Amendments to the Drawings:

REMARKS/ARGUMENTS

Appl. No. 10/774,735
Amdt. dated July 26, 2005
Reply to O.A. of April 27, 2005

FIG. 4a.

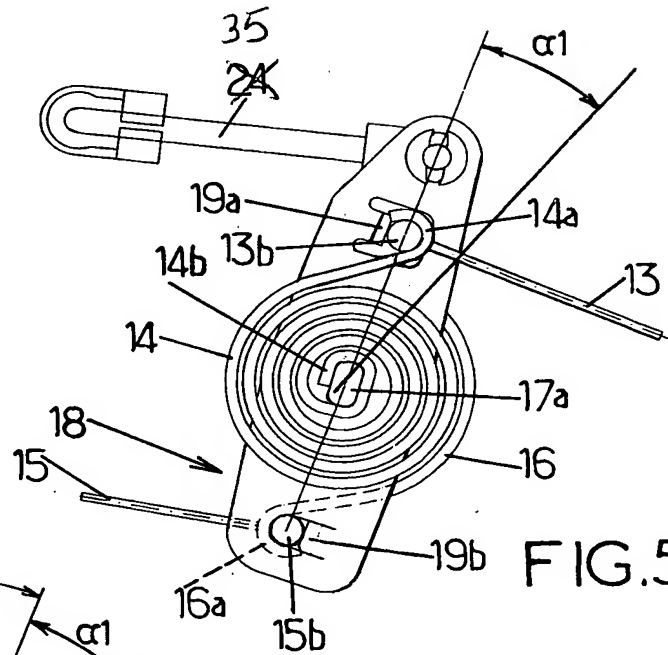
Element "24" has been changed to "35" on Figs. 4a, 4b, 5a, 5b, 6a and 6b.
